**CENTURY OAKS
ABG DEVELOPMENT
MDP/P.U.D. PLAN**

The City Staff Development Review Committee has reviewed Century Oaks (Amending) Master Development Plan M.D.P. (formerly POADP) Preliminary Overall Area Development Plan # 460-B. Please find enclosed a signed copy for your files. Your plan was accepted however please note the following:

The City Staff Development Review Committee has reviewed Century Oaks (Amendment) Preliminary Overall Area Development Plan/ Planned Unit Development (PUD). Please note that your plan was not accepted, based on the following:

120' R.O.W. STREET SECTION
PRIMARY ARTERIAL STREET
NOT TO SCALE

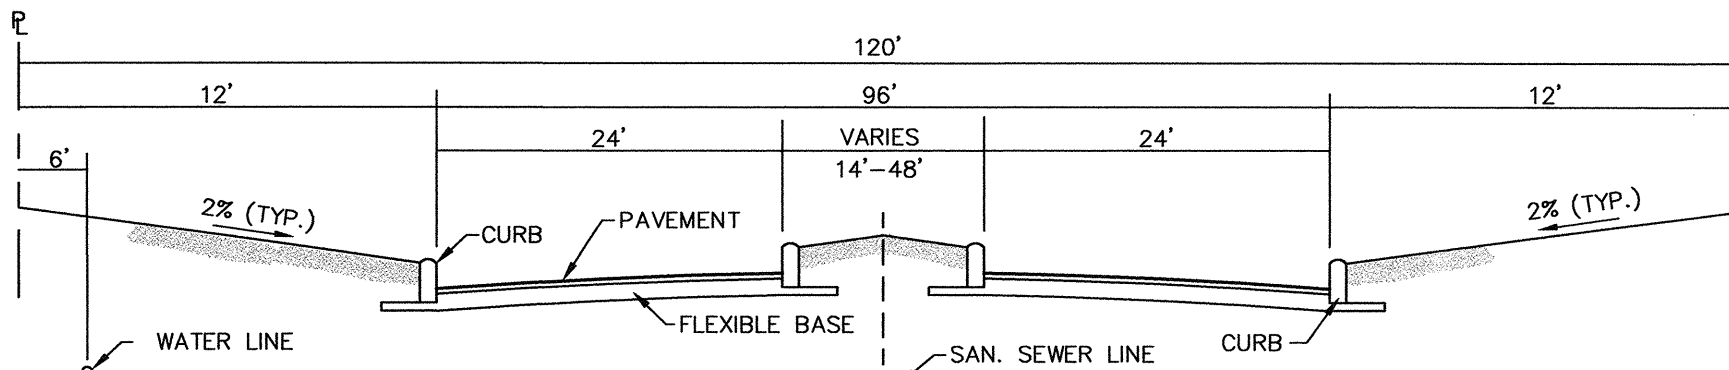
- Intersection of Cibolo Canyon and Evans - Additional ROW (120 – feet in width) has been provided on Cibolo Canyon. The added ROW will allow future expansion of the intersection to possibly allow dual left turns and a right turn deceleration lane for Cibolo Canyon.
- Right turn deceleration lanes shall be constructed on Cibolo Canyon and Evans Road for all collector streets accessing these arterial streets. This construction may require dedication of additional right-of-way.

86' R.O.W. STREET SECTION
SECONDARY ARTERIAL STREET
NOT TO SCALE

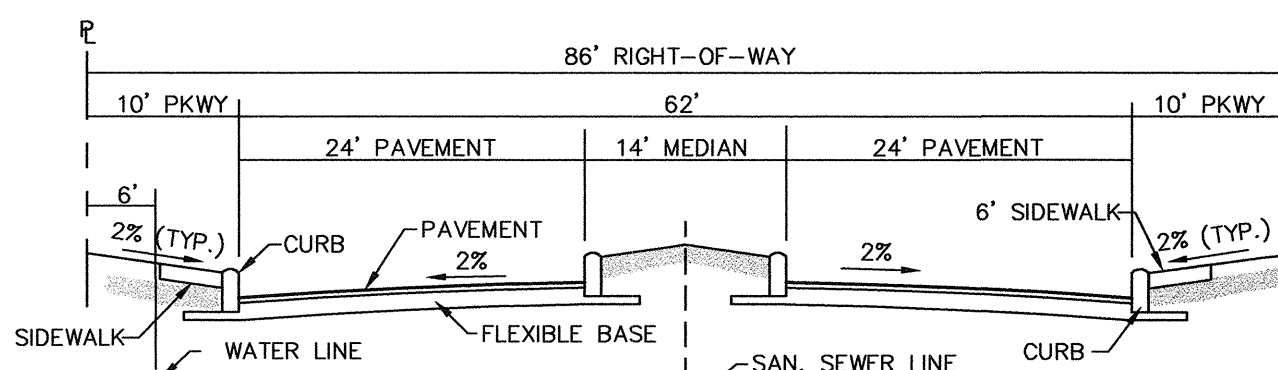
- Cibolo Canyon - Dedicate 86-feet of ROW and construct a 4-lane divided roadway (Secondary Arterial Type B). The limits of construction shall be extended from Evans Road to Angosturo Boulevard as shown on the City of San Antonio Major Thoroughfare Plan (MTP).

- Option # 1, Exhibit- "A"
- As per (UDC) section 35-4109

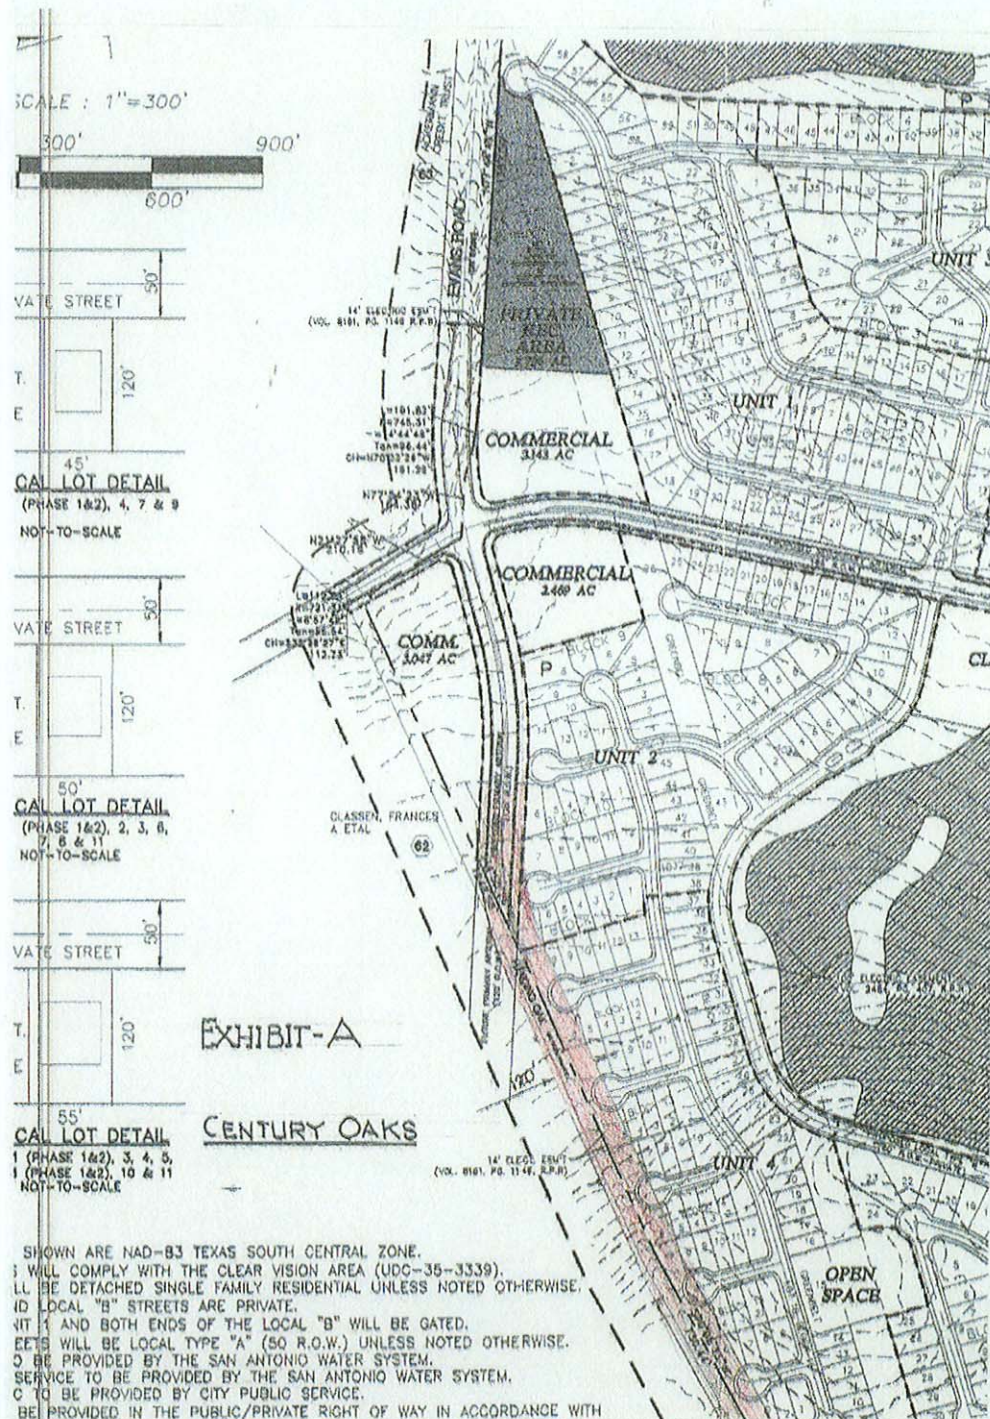
- 1) The plan does not comply with (old UDC) Section 35-4109 Arterial streets

"Where a Primary or Secondary Arterial street, as shown on the Major Thoroughfare Plan, traverses or is contiguous with an area being platted, such Primary or Secondary Arterial Street shall be platted in the location and of the width indicated by the requirements of the Major thoroughfare plan and these regulations."

Evens Road is on the Major Thoroughfare Plan and calls for a Primary Arterial Type "A"; your proposal fails to identify this Primary Arterial as proposed on the Major Thoroughfare Plan for the City of San Antonio.
